Staff Report

Infill Housing Design Review Committee

File Number: 5-B-24-IH

Level III New Primary Structure

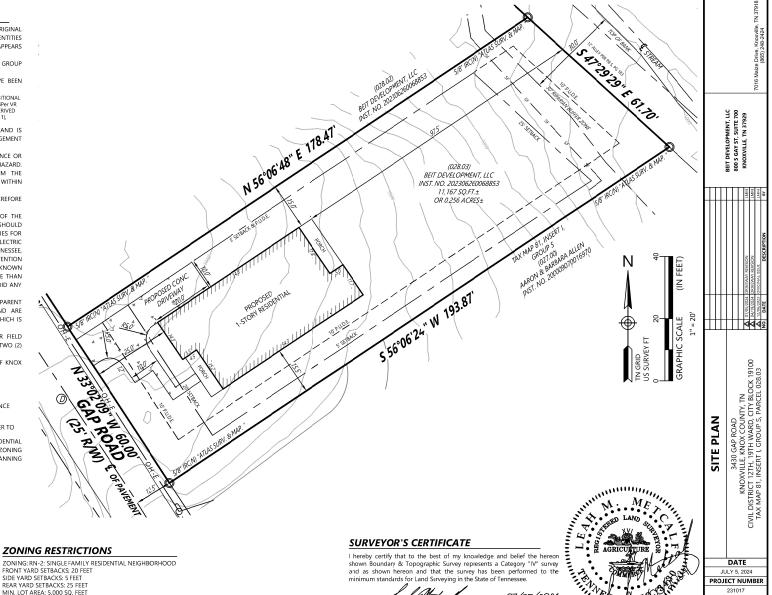
1. The house is proposed to be set 25' from the front property line. The block to receive new construction is relatively undeveloped; however, the existing houses on the block are set 15' and 18' from the front property line. The revised proposal has been aligned to align the four new houses on the block.

3. The application proposes a concrete driveway in the front of the house. Infill Housing guidelines recommend that on streets without alleys, parking areas should be at least 20' behind the front façade of the house with access limited to one lane between the street and the front façade. The turnaround may be required based on the site's topography and the conditions of Gap Road, but should be omitted if possible. Final site plans should meet City Engineering standards.

5. The revised application includes a 4'-5" deep entry stoop on the site plan and an 8' deep front porch on the floor plans. While an 8' deep porch meets the guidelines, the final site plan should include an accurate porch measurement.

9. Final site plans should include one native or naturalized shade tree in the front and rear yards. The lots currently feature a substantial amount of trees and other vegetation; existing trees should be retained if at all possible.

Front set back for each home will be normalized to create a consistent streetscape pattern.

Parking / driveway will be altered to meet guidelines

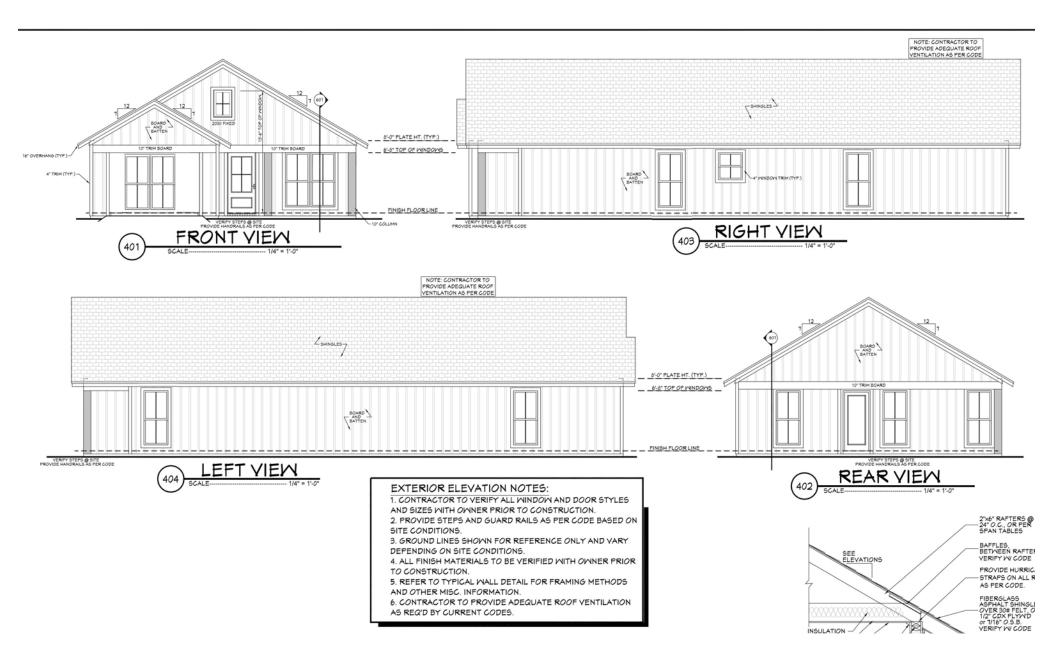
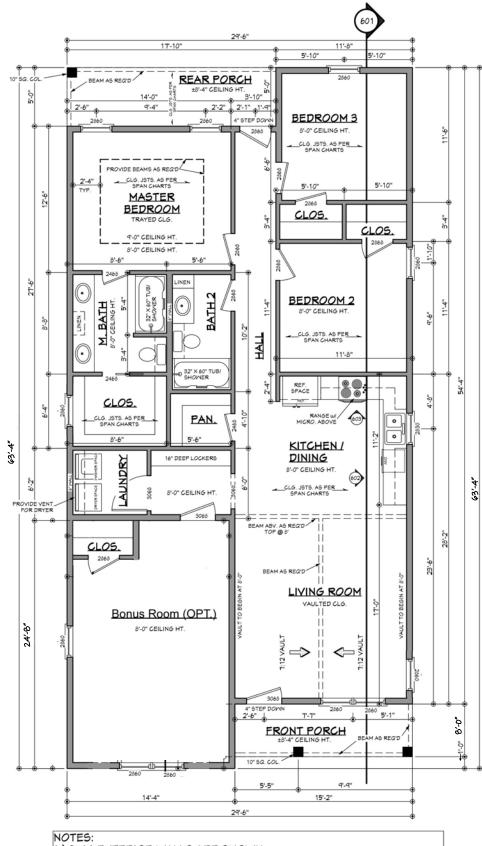
4. Overall, the one-story, three-bay façade is similar in scale and width to the context. The house is proposed for a concrete slab foundation; the foundation should be at least 12" tall to be compatible with the broader neighborhood. Topography of the site may also affect the house's foundation; the drawings depict a concrete slab.

6. Guidelines recommend window and door styles be similar, with similar proportions and ratio of solid to void, to historic houses on the block and in the neighborhood. The revised application includes two windows on the left elevation and three on the right elevation.

8. The application does not include information on siding materials. Guidelines recommend that clapboard-like materials be used in new houses and discourages vertical siding; the houses should feature horizontal lap siding instead of board-and-batten. Final drawings should accurately show the siding to be installed.

Foundation plan (below) does not specify a total height. Crawl space will exceed the 12 inch requirement

Revised plan emailed in separately to Lindsay Crockett

Revised plan emailed in separately to Lindsay Crockett

Siding will be horizontal lap siding
